West Parish Filters Water Treatment
Plant
1515 Granville Road
Westfield, MA 01085
Project No. 24-51

ADDENDUM NO. 16 06/18/2024

ADDENDUM NO. 16

DATE: FEBRUARY 2024
HAZEN NO.: 90398-004
CONTRACT NO.: 24-51
DRAWING NUMBER:
C-243

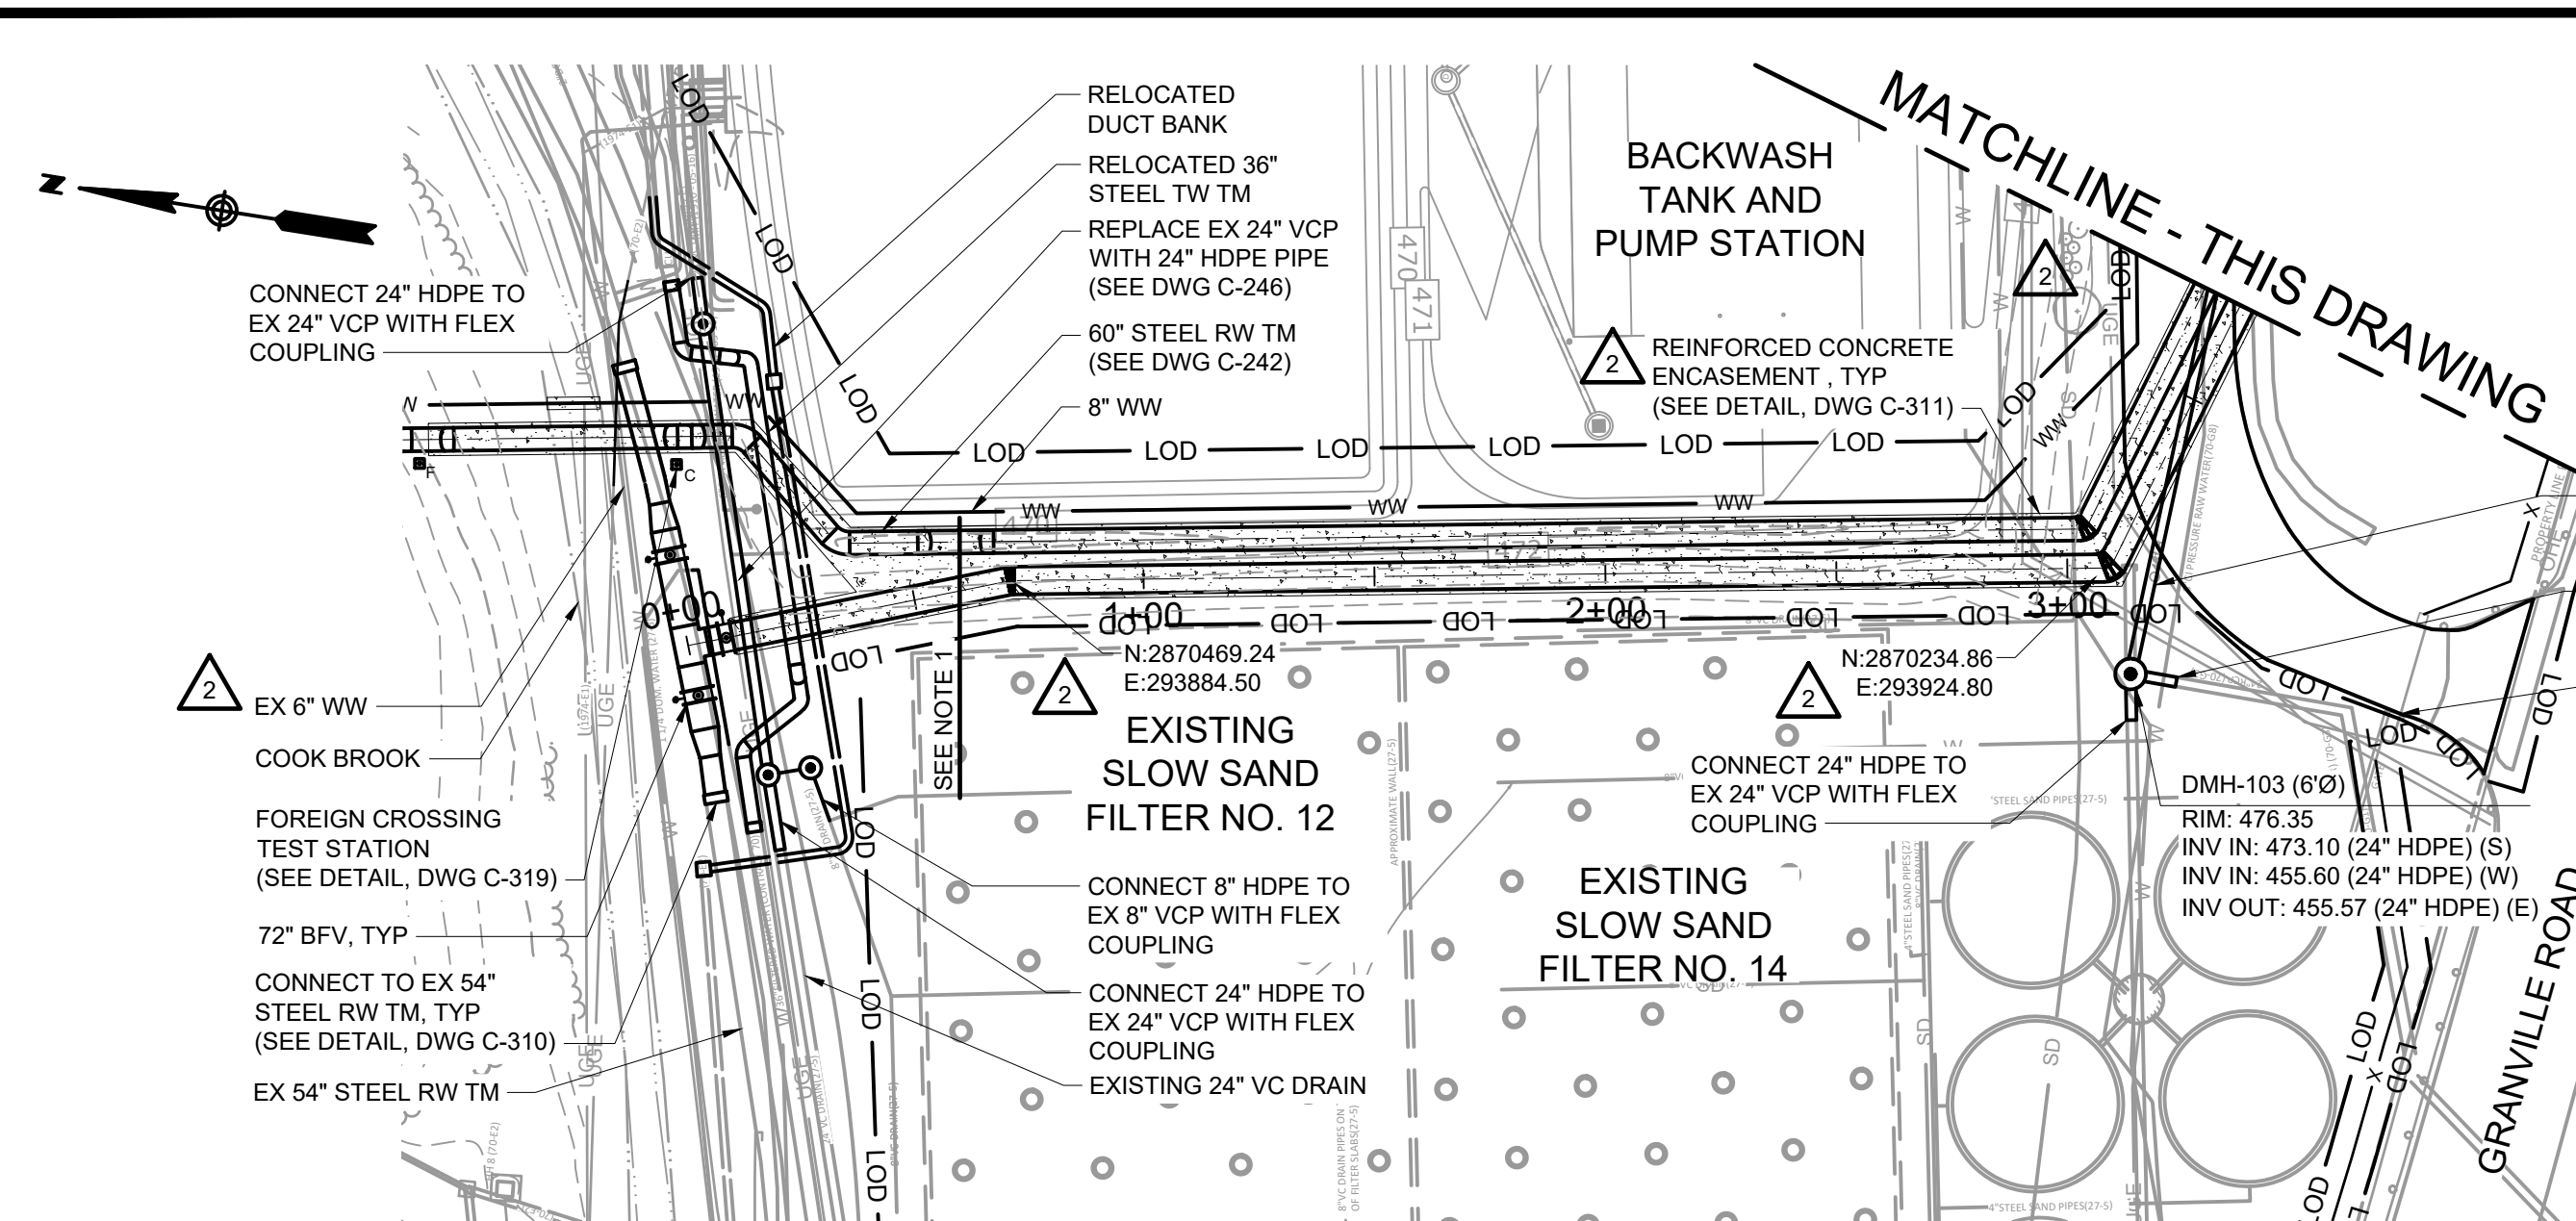
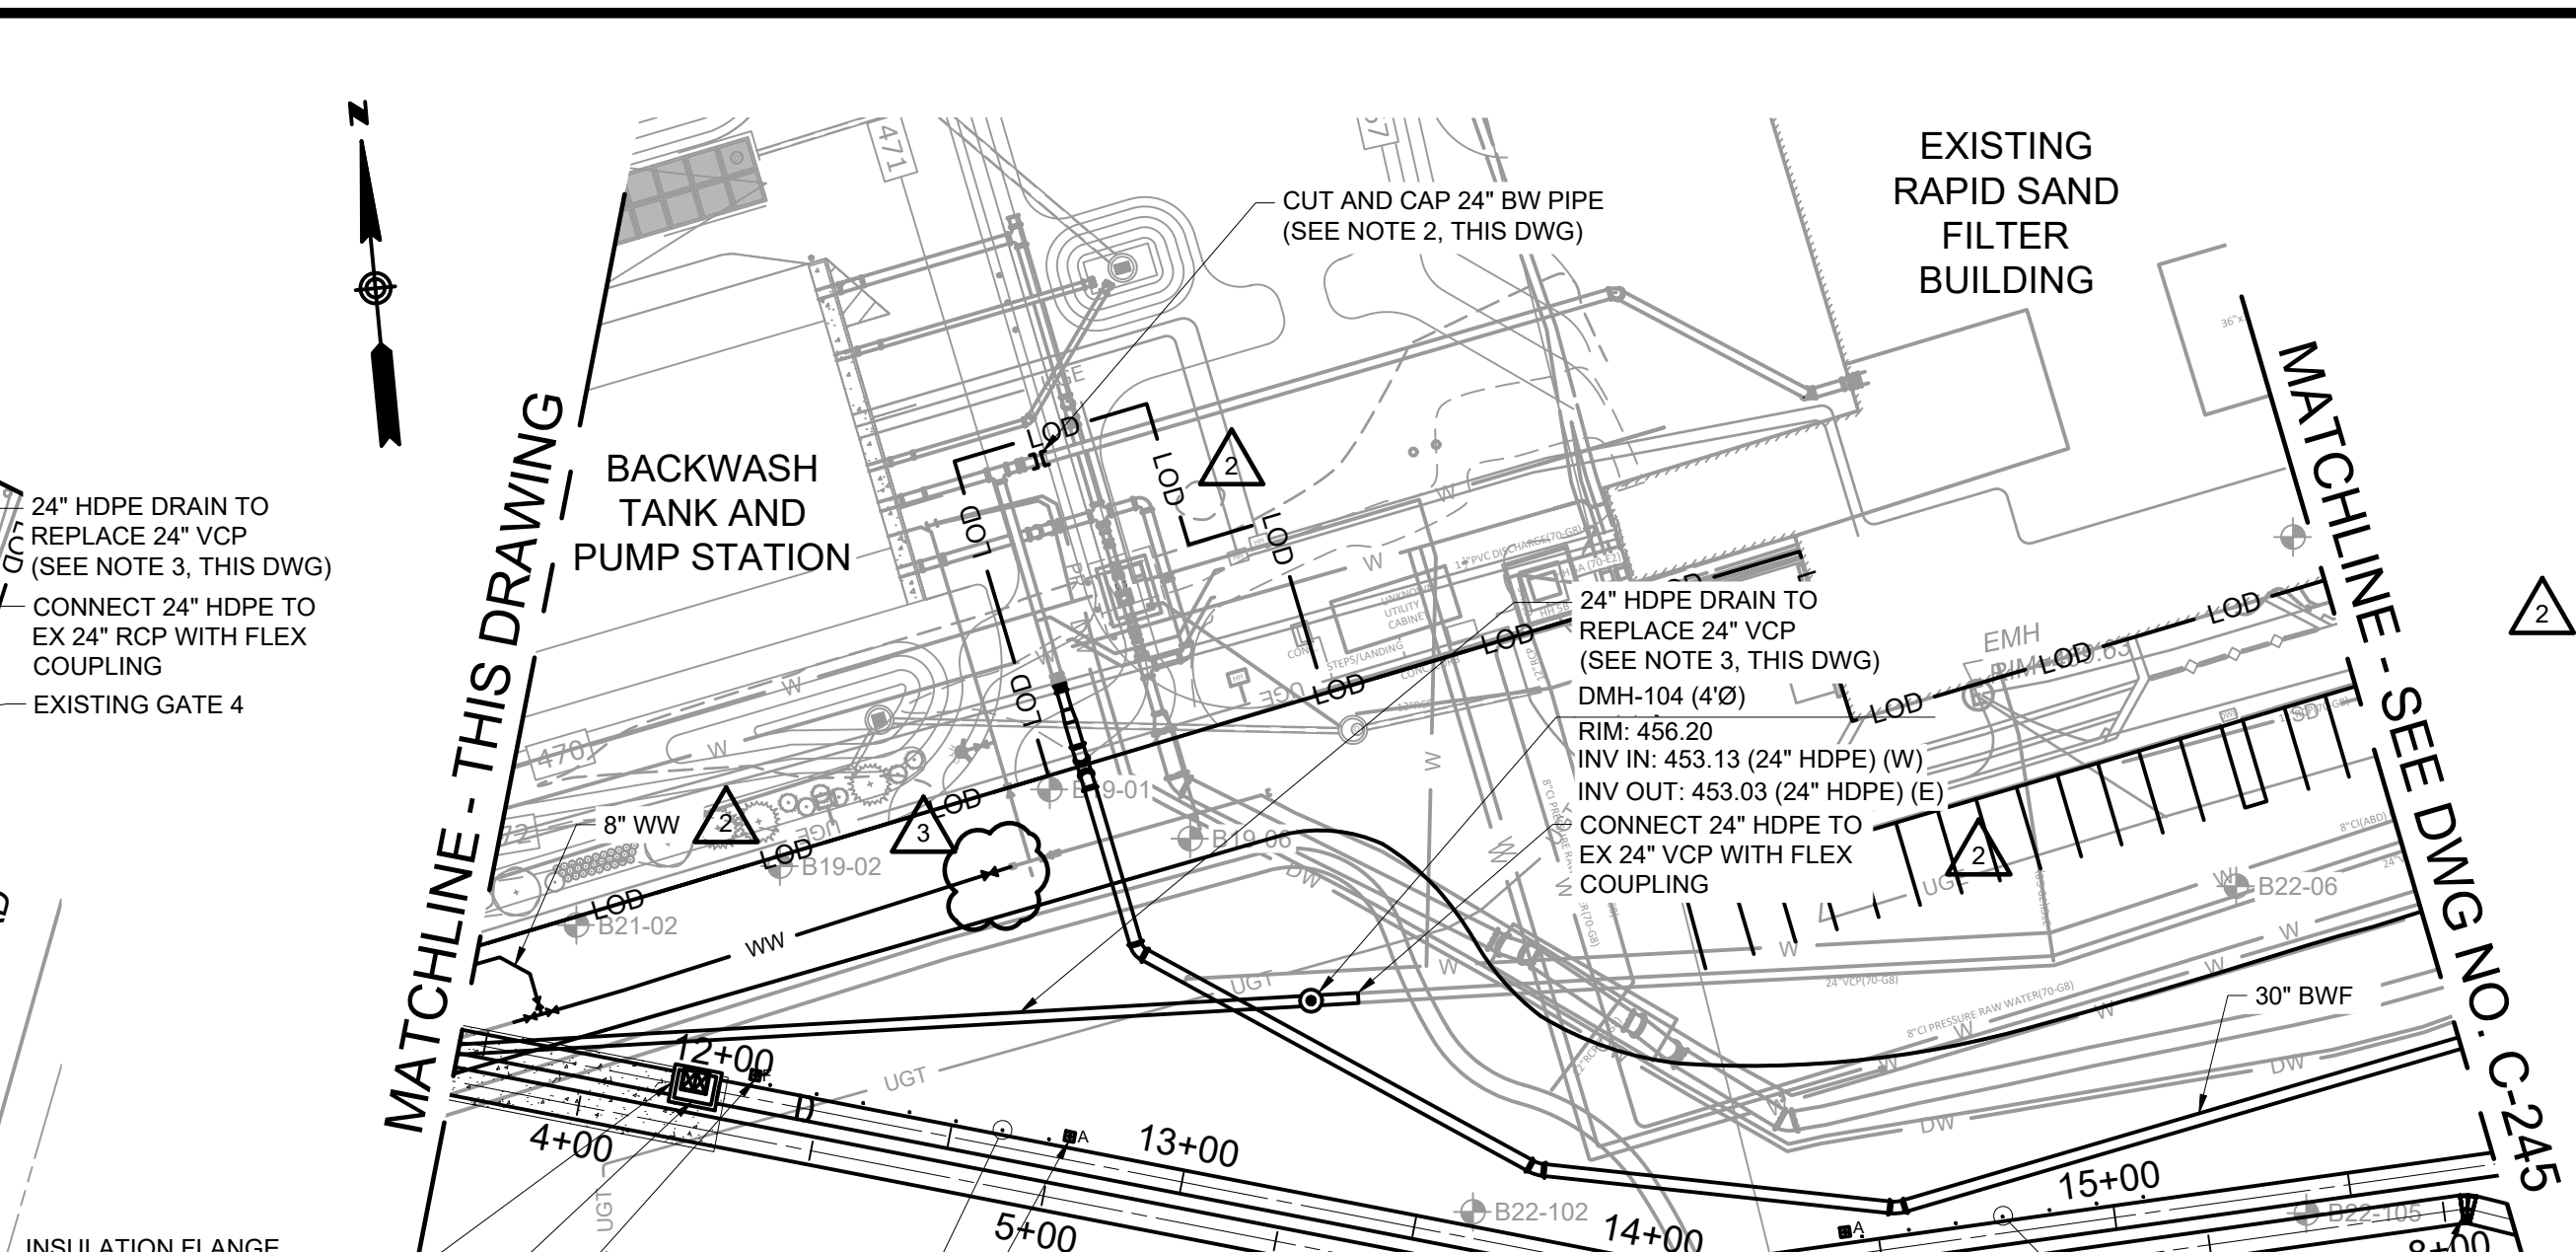
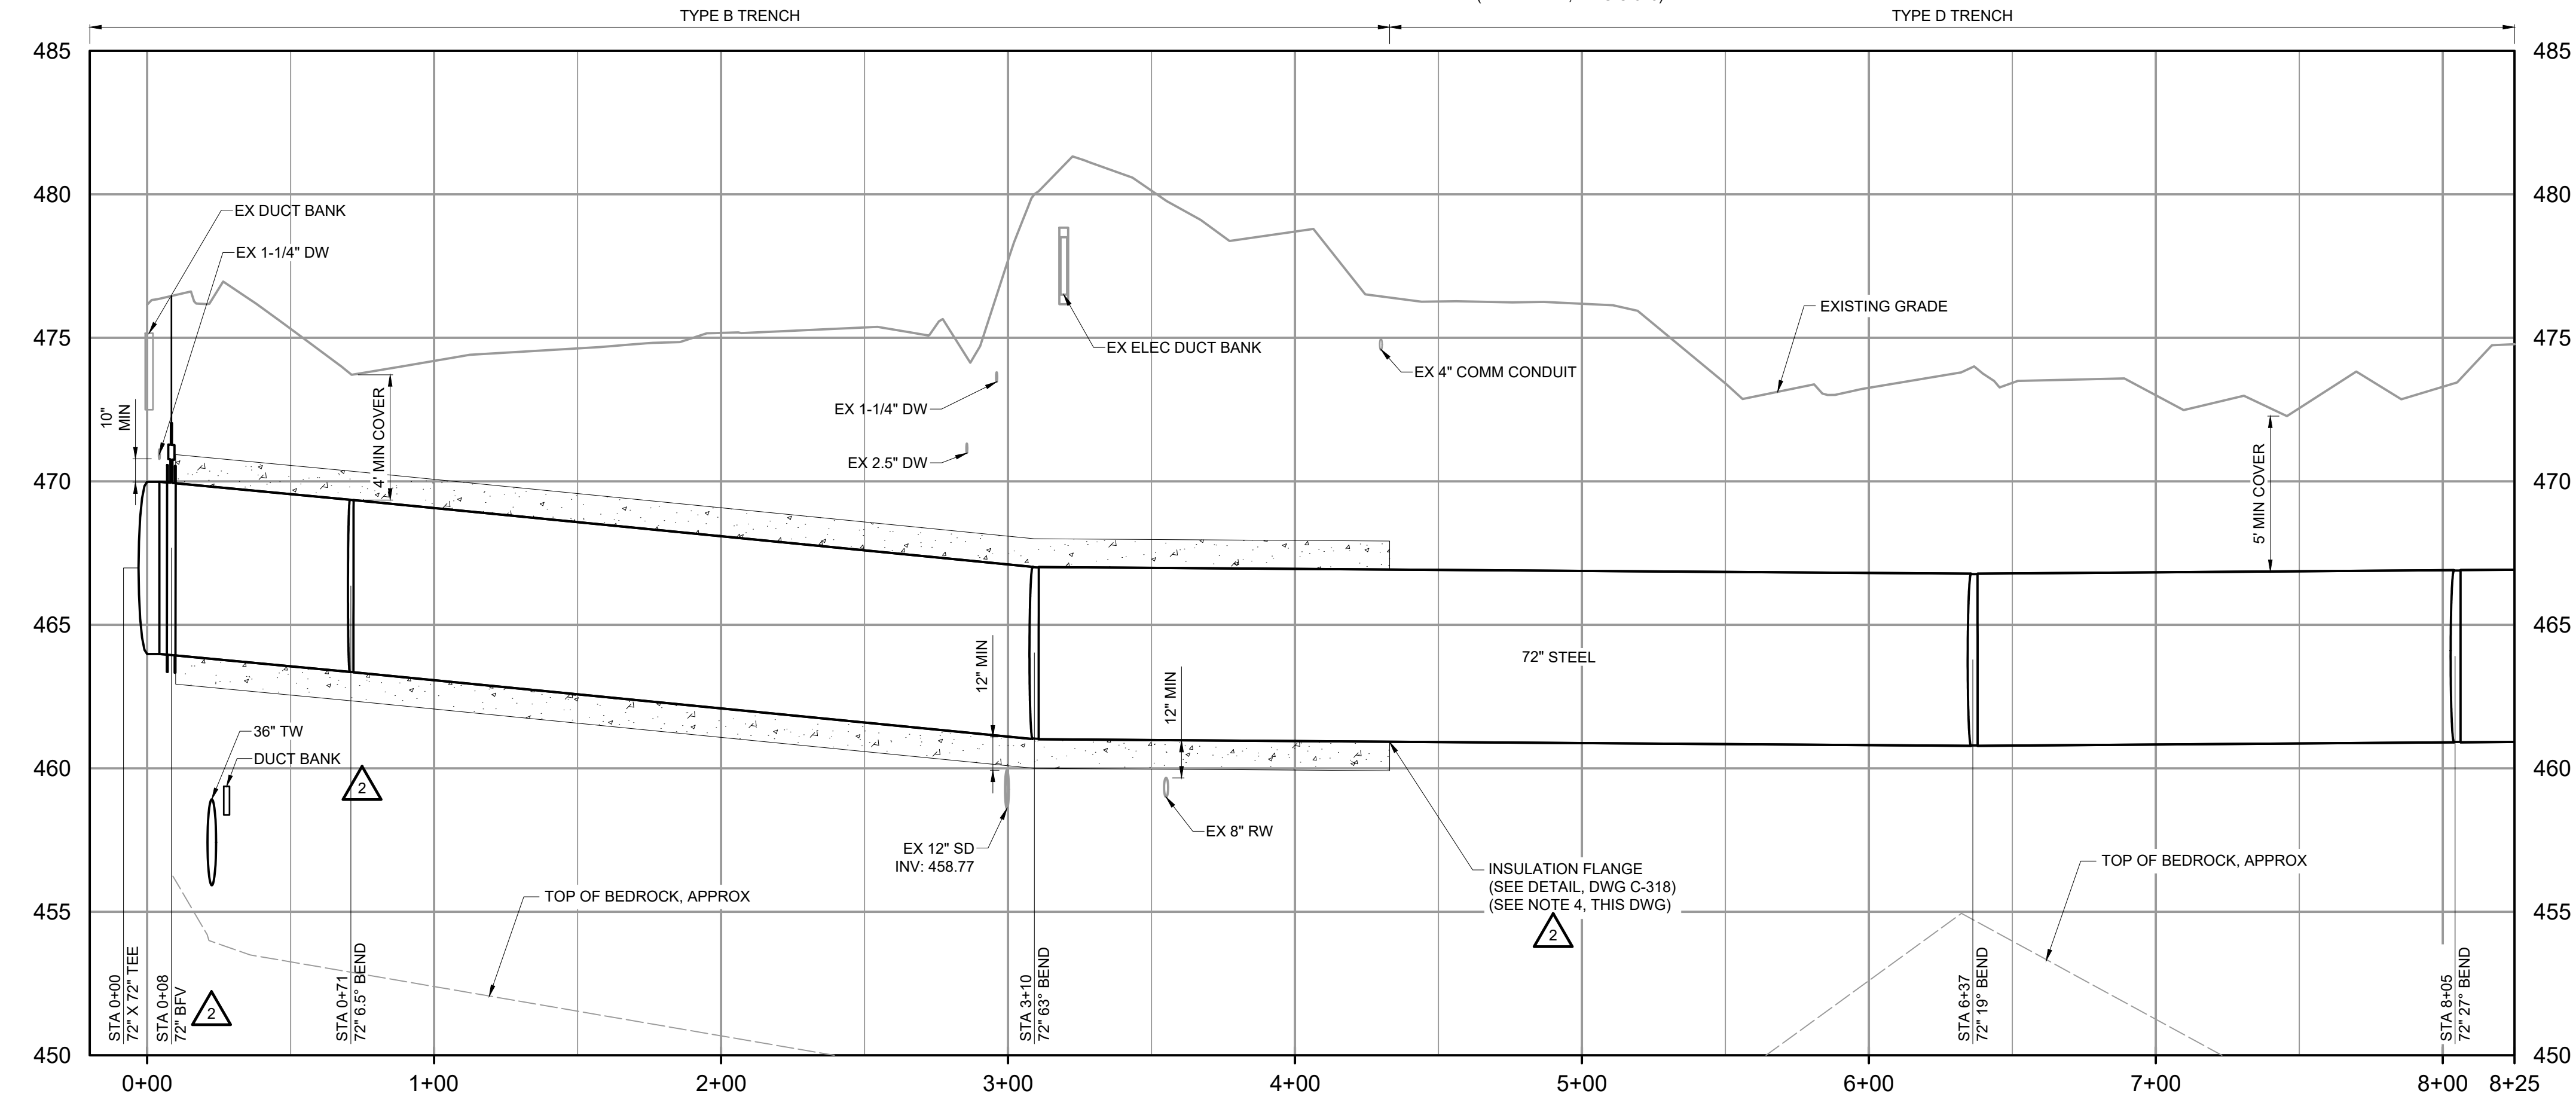
16-Q10	3. Addendum 12, Form of General Bid, page 6, 2nd paragraph – Clarify why the Contractor is paying the premiums for the performance and payment bonds for the Pre-Selected Filed Sub-Bidders?	Language is per the statutory requirements of MGL 149, section 44E.
16-Q11	4. Addendum 12, C-241, C-242, and C-243 plans appear to mislabel the Type B and D trenches as they relate to C-317 trench details. Confirm Type D trench is only required at the concrete encased TM.	The raw water transmission mains shall be encased as indicated on drawing C-241, C-242, and C-243. The encasement is reinforced as detailed on drawing C-311. The reinforced encasement shall be backfilled as indicated on the profile drawings, Type B. The sections of TM that are called out with a Type D trench, shall be backfilled with flowable fill. Note 1 on drawings C-243 and C-245 was revised to match Note 1 on drawings C-241, C-242, C-244.
